Memo

Date: April 28, 2023

Re: Perkins Pasture Subdivision - Stormwater Management and Design Review

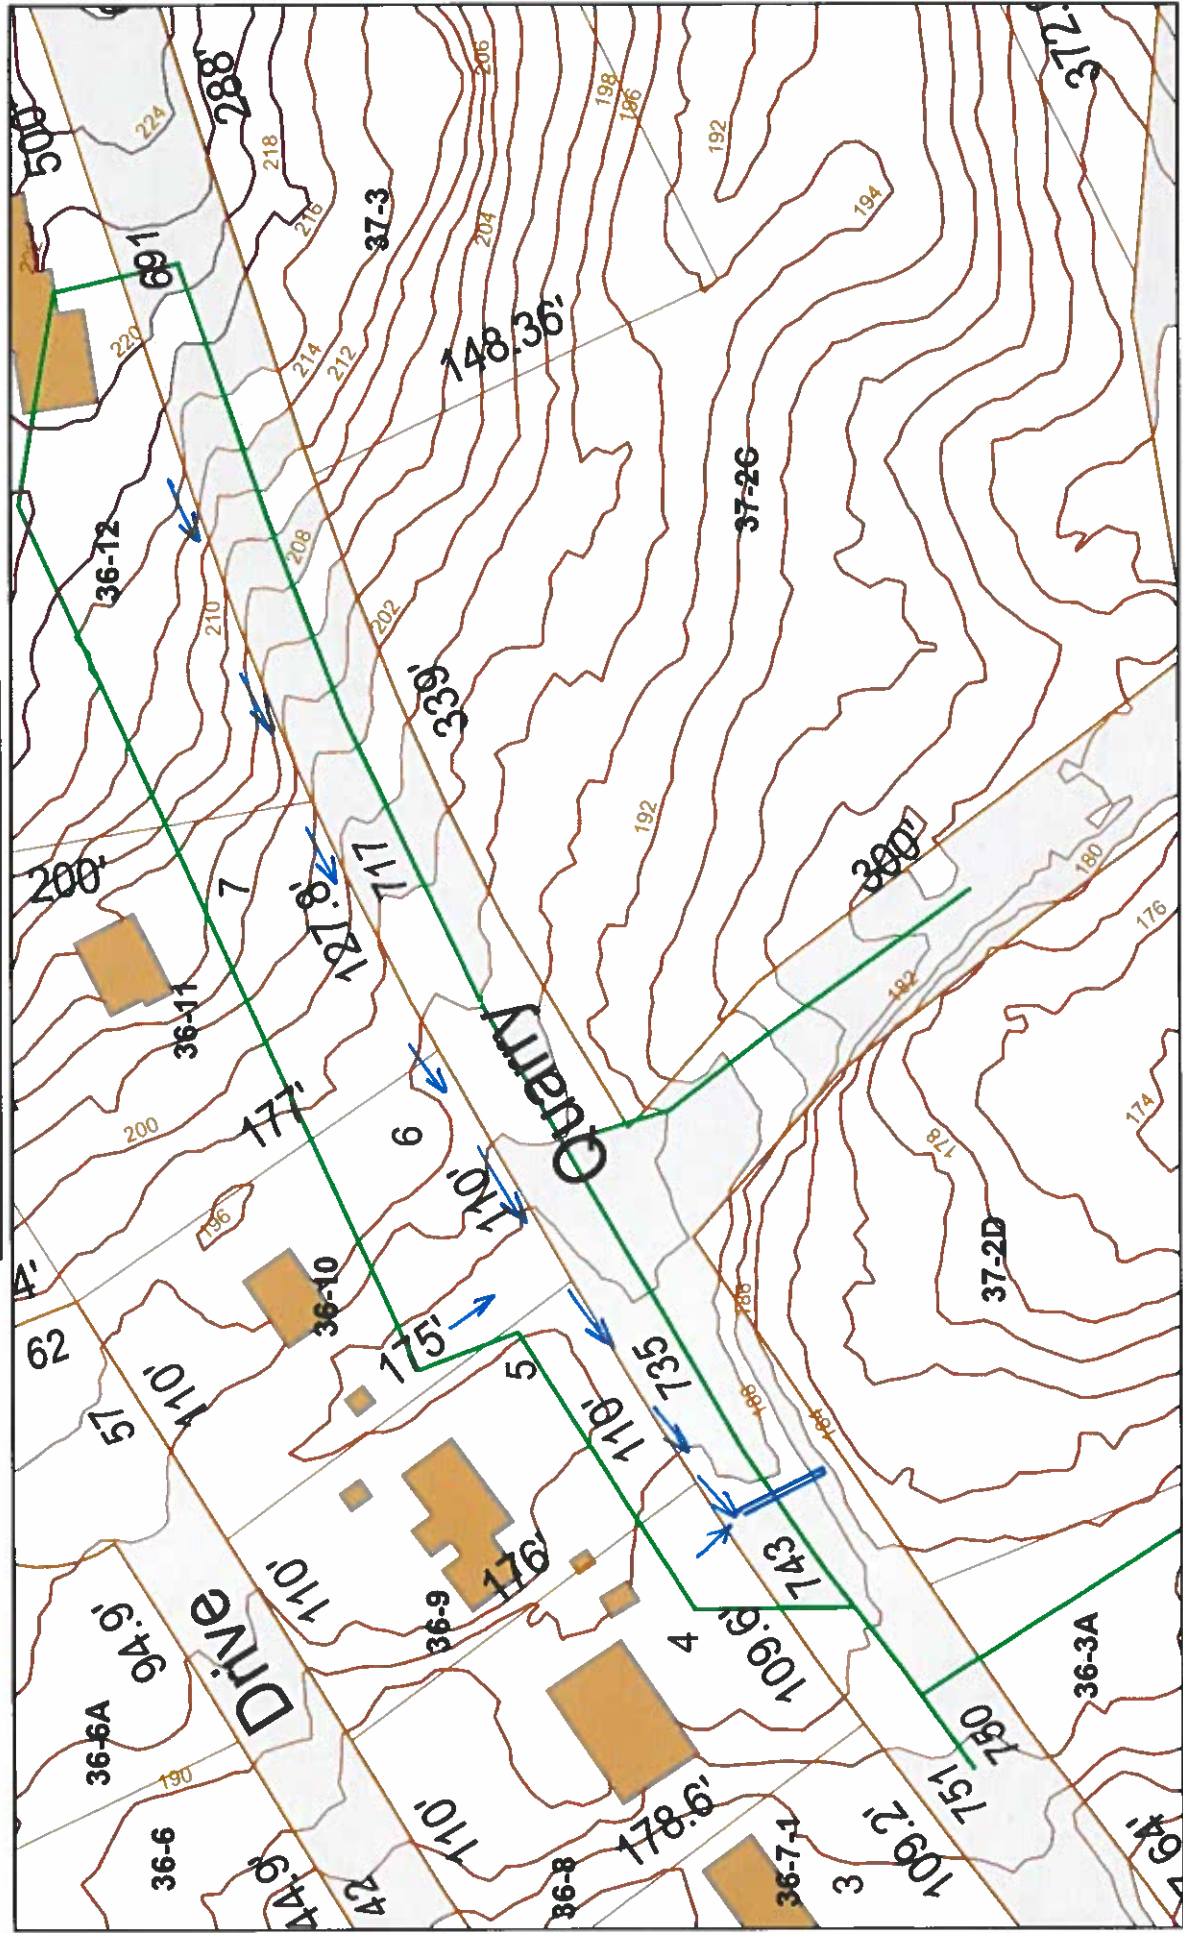
Lot 17: Plans indicate an existing cross culvert under Quarry Road which drains a significant upslope area, see sketch. Development of Lot 17 will affect the drainage from the Town road.

- A drainage easement is needed across Lot 17 to the existing wetland area
- The easement to be 20 feet in width and conveyed to the Town prior to an occupancy permit or prior to the conveyance of Lot 17
- See attached sketches A and B of possible locations
- Option A would require a swale to be constructed
- A small amount of wetland fill should be considered to accommodate development
